# PENROSE LIBRARY FENCE – FBZ WARRANT APPLICATION Downtown Review Board - May 7, 2024

Staff Report by Case Planner: Johnny Malpica, AICP

File Number	Application Type	<b>Decision Type</b>
FBZN-24-0005	Form-Based Zone Warrant	Quasi-Judicial

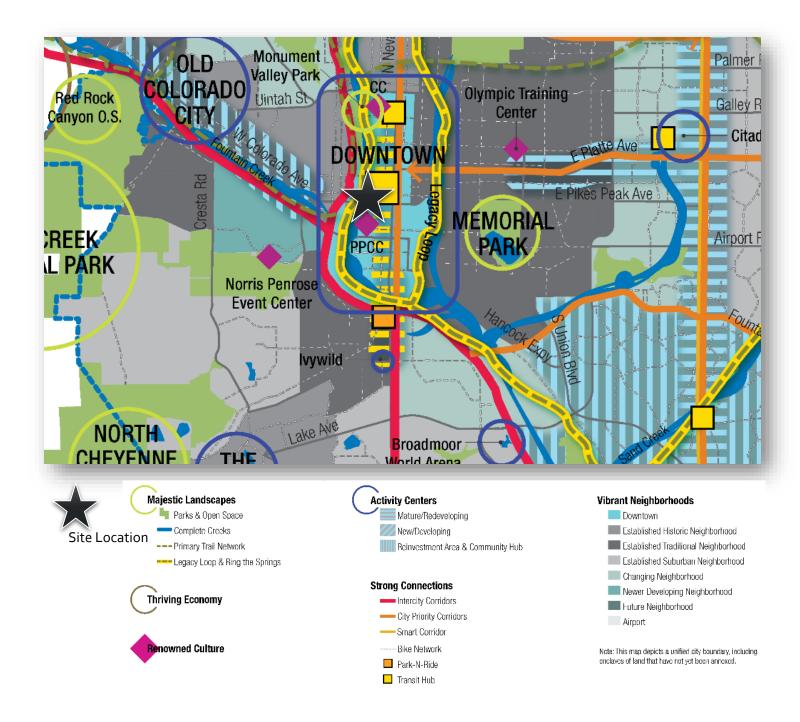
The applicant's proposal to construct a 7' fence around the entire perimeter of the Penrose Library campus is intended to ensure a safer and more comfortable environment for patrons. Through the provision of attractive fencing materials, they aim to reduce the burden of the aforementioned security and safety issues, while minimizing the impact on the site's relationship with the public realm. Attention has been given to the component that a key reason for the adoption of the Form-Based Code, the City's Comprehensive Master Plan, and the Downtown Master Plan is to promote the health, safety, and general welfare of the City of Colorado Springs and its residents, and there are existing safety concerns affecting these quarantees. However, it is imperative to understand this proposal's impact on the site's function as a key civic institution and its building frontage typology, which is established as a Common Lawn that shall remain unfenced and visually contiquous with surrounding properties. The proposed fencing will visually and physically disconnect the site from the public realm. As such, the proposal as it is submitted is not consistent with the intent of the Form-Based Code. Furthermore, the proposal is not consistent with Section 4 - Design Guidelines of the Form-Based Code, as it reduces existing pedestrian access into the building by fencing in the plaza space along N. Cascade Ave., which will in turn reduce pedestrian use of the plaza space fronting an important historic and cultural resource to the City of Colorado Springs. While the proposed warrant may be considered reasonable due to the project's exceptional civic design, Staff finds that the design detracts from the existing open and invitational civic nature of the plaza space. As a remedy, staff provides a number of alternative considerations, which better balances both the assuagement of existing safety concerns while more strongly aligning with the intent of the Form-Based Code.

With recognition given to the above, staff recognizes that the present issues create unfortunate safety concerns for patrons of the library. However, it is important to note that similar issues occur throughout many of downtown's public amenity spaces, all of which remain unfenced. Libraries are intended to be public environments, to be enjoyed and open to all. It is for these reasons that the proposal does not align with the Experience Downtown Master Plan and the City's Comprehensive Plan.

The Downtown Review Board may consider alternative solutions and modifications to the proposal that more effectively balances ensuring safety and comfort without compromising visual contiguity and the relationship of the site with the public realm. Those

considerations may include further consultation with Planning Staff and the applicant to modify the proposal to limit enclosing the plaza space along N. Cascade Ave., as well as modifications to the fencing along the property line adjacent to W. Kiowa St., both of which serve as important pedestrian-oriented spaces within the Downtown.

With consideration given to the above review criteria, the cultural significance of the Penrose Library, its location and relationship to the pedestrian environment that surrounds it, Staff concludes that the review criteria have not been met and suggests the proposal be modified to better meet the Common Lawn frontage standard and the criteria above.
